2 SITE CHARACTERISTICS

2.4 Hydrologic Engineering

Figure 2.4.2-2 The Site Drainage Area at the WLS Site (Adapted from WLS COL FSAR Revision 7, Figure 2.4.2-202)

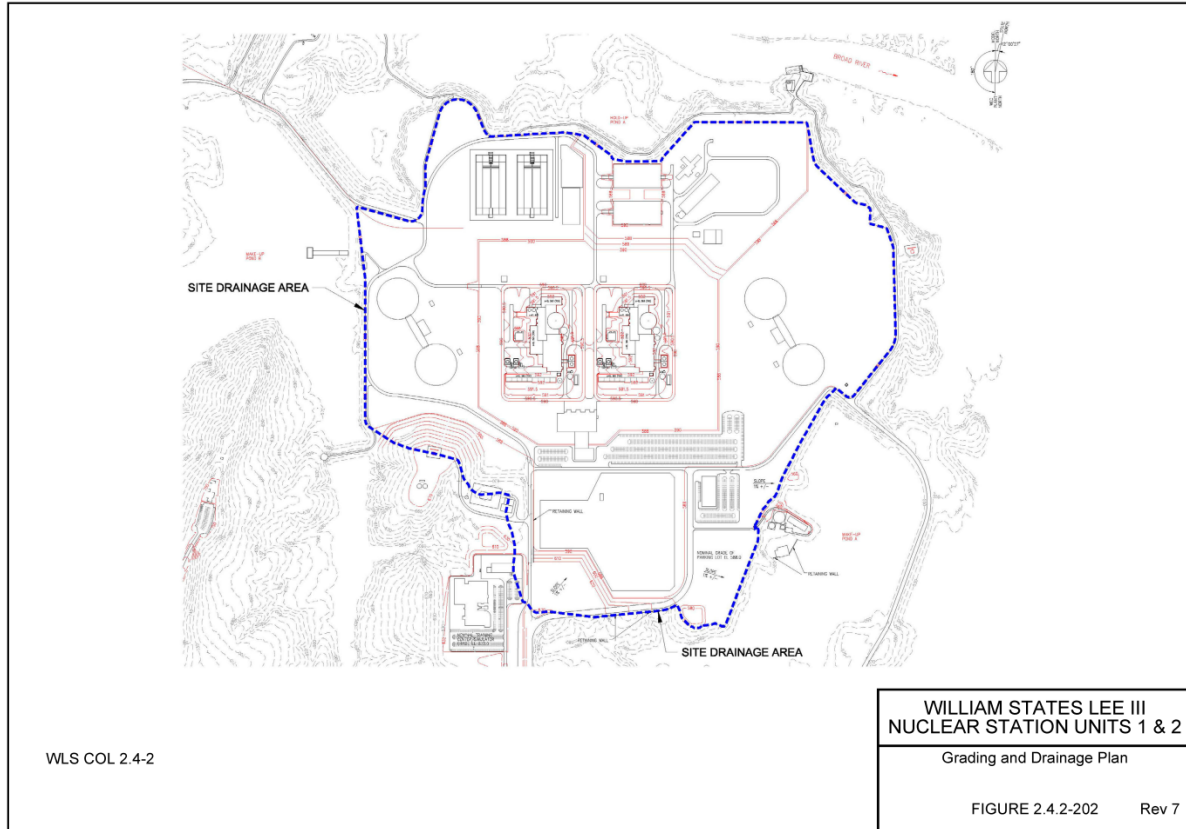
The applicant stated that elevations immediately adjacent to the nuclear power block areas enclosed by a roadway, range from the nominal plant grade of 180.4 m (592 ft) to 179.8 m (590 ft) above MSL. Farther away from this area, the grade is flat from the roadway to the plant side of the vehicle barrier system at 179.8 m (590 ft) above MSL. The outer bank of the vehicle barrier system is at an elevation of 179.2 m (588 ft) above MSL. Farther outside the vehicle barrier system, the WLS site is flat at an approximate elevation of 179.2 m (588 ft) above MSL before steeper slopes that form the banks of the adjacent water bodies including Make-Up Ponds A and B, Hold-Up Pond A, and the Broad River. The WLS site drainage area is shown in Figure 2.4.2-2 of this report.

Figure 2.4.2-3 Drainage Pattern within the Nuclear Power Block Areas of the Two Units

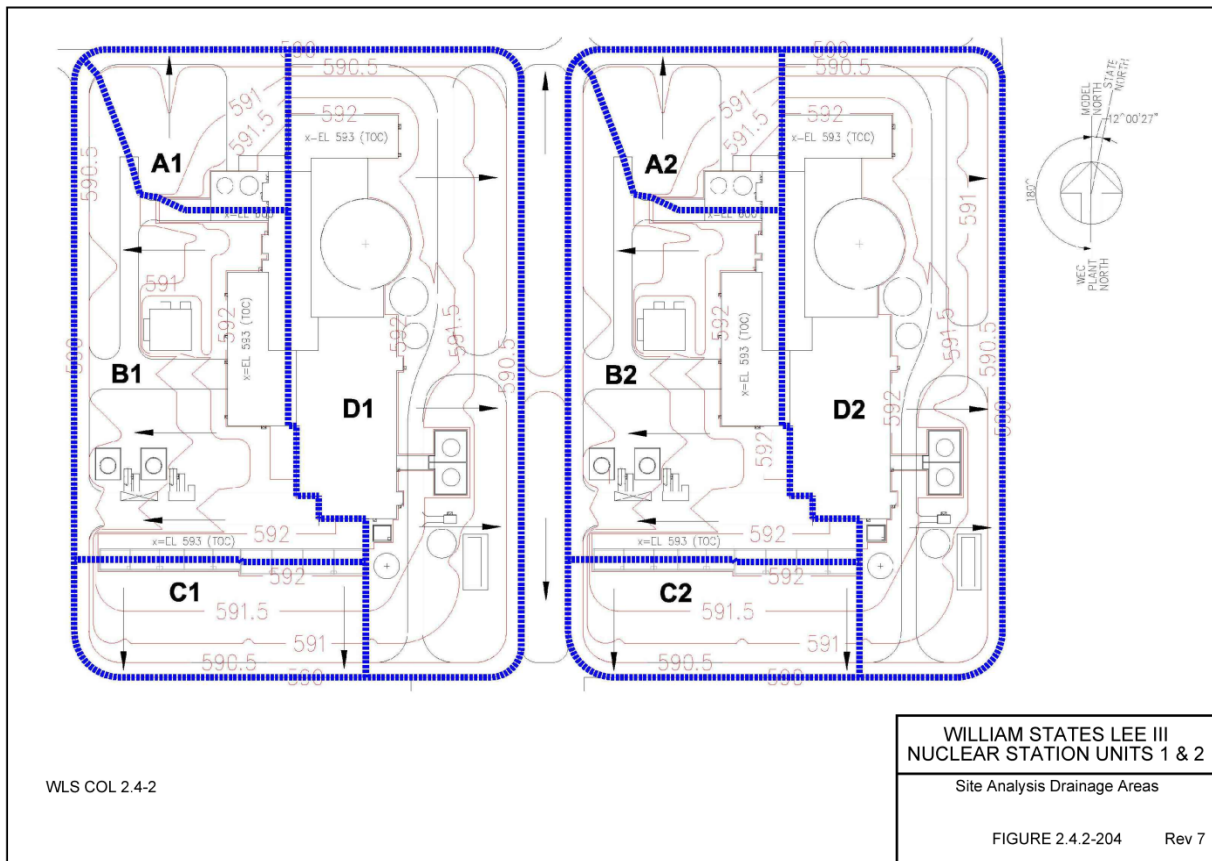
To understand the analysis performed by the applicant related to the runoff from and water-surface elevations on site drainage areas under local intense precipitation, in RAI 820, Question 02.04.02-2, the staff requested that the applicant: (1) provide input files used in the HEC-RAS analysis described in WLS COL FSAR Section 2.4.2.3; (2) provide details of the iterative process used with the HEC-RAS model to determine water-surface elevations during the local intense precipitation event described in WLS COL FSAR Section 2.4.2.3; (3) provide details of how the times of concentration for the site drainage areas were determined; and (4) provide the locations of safety-related structures where the maximum water-surface elevations for each of the site drainage areas occurred. In an October 27, 2008, response to RAI 820, Question 02.04.02-2, the applicant stated that HEC-RAS and HEC-HMS electronic input and output files were provided to the NRC. The staff used these files to review the applicant's analysis described in WLS COL FSAR Section 2.4.2 and to perform independent confirmatory analyses. The applicant stated that the AP1000 safety-related structures are the containment building and the auxiliary building. The applicant identified these structures on a figure provided with the RAI response.

The staff evaluated the applicant's responses to the RAIs and determined that the applicant has adopted a reasonable approach to identify the effects of local intense precipitation. The staff reviewed the proposed post-construction elevation contour map of the site extending out from the nuclear power block area and determined that the identification of the four subareas based on the site grading plan and the location of safety-related SSCs conform to the elevation contours. The applicant used the Rational Method with an assumption of no losses to estimate the discharges in the four subareas. The applicant used the HEC-RAS hydraulic simulation software to estimate water-surface elevations under steady conditions. The staff concluded that these are conservative approaches and therefore, the applicant's methods for determination of discharges and water-surface elevations during the local intense precipitation event are adequate. Accordingly, the staff considers RAI 820, Question 02.04.02-2, resolved.
